**Victoria County Groundwater Conservation District
2026 Proposed Rules of the District**

August 24, 2026

On behalf of the Port of Victoria (POV), Advanced Groundwater Solutions, LLC (AGS) has prepared the following comments based on its assessment of the Victoria County Groundwater Conservation District's (VCGCD or District) June 2026 and July 2026 Proposed Rules (Proposed Rules). Attachment A lists the documents AGS reviewed and analyzed in the preparation of its comments.

Figure 1. Port of Victoria Site location showing depth to base of groundwater with < 1,000 mg/L TDS (freshwater). Contours shown are based on the INTERA (2026a) Report.

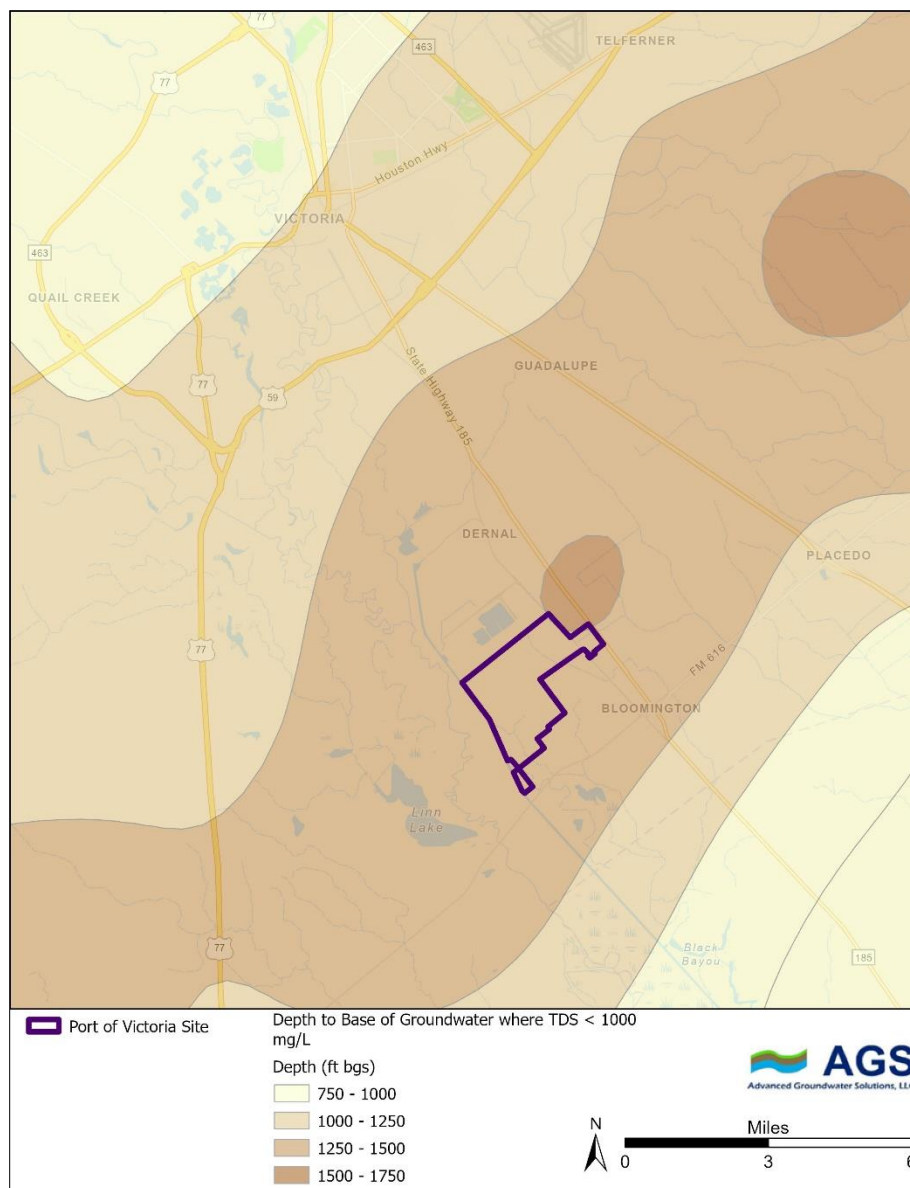
Any uncertainty in delineation of TDS zones may propagate into the Proposed Rules' water volume calculations for each zone. The Proposed Rules simplify the more detailed INTERA assessment into zones and volumes that do not accurately reflect the technical analysis on which they were supposedly based. For example, in the Proposed Rules, VCGCD presumes the depth to saline groundwater at the Port of Victoria's site is 1,200 ft. However, the INTERA (2026a) Addendum Report, Figures 2-39, suggest that the depth to the base of groundwater where the TDS < 1,000 mg/L at POV's site is deeper, in the range of 1,250-1,500 ft bgs, and is adjacent to property where this groundwater base is located 1,500-1,750 ft bgs (Figure 1).
